Subject: NOISE FROM REAR BRAKES DUE TO BRAKE DRAGGING	Bulletin No.: 04-005/17
	Last Issued: 07/21/2017

2016 CX-5 vehicles with VINs lower than JM3KE*****866136 (produced before September 9, 2016)
2016 CX-9 vehicles with VINs lower than JM3TC*****120519 (produced before September 15, 2016)

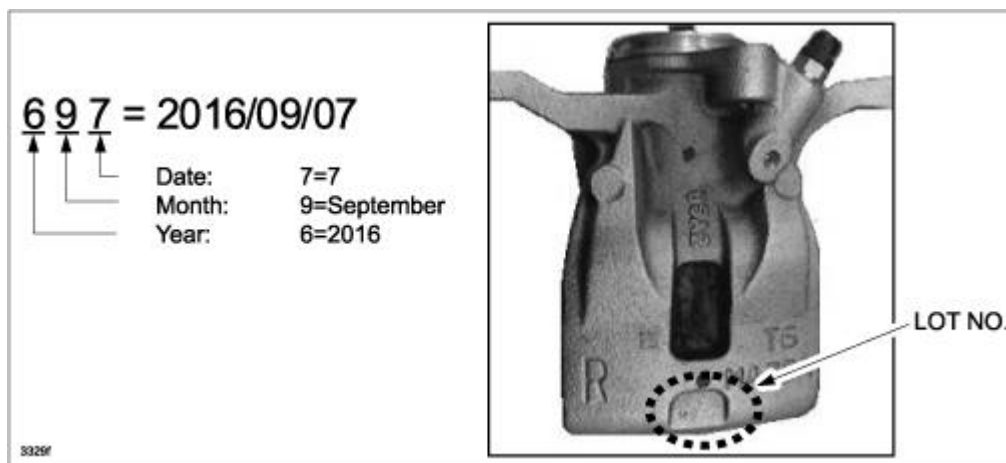
NOTE: Part numbers of caliper have not been changed by this modification. Distinguish the modified one from old one using the 3-digit lot number (Production Date) stamped on the caliper. Calipers with the lot number (production date) of **697 (2016/09/07)** and higher are modified.
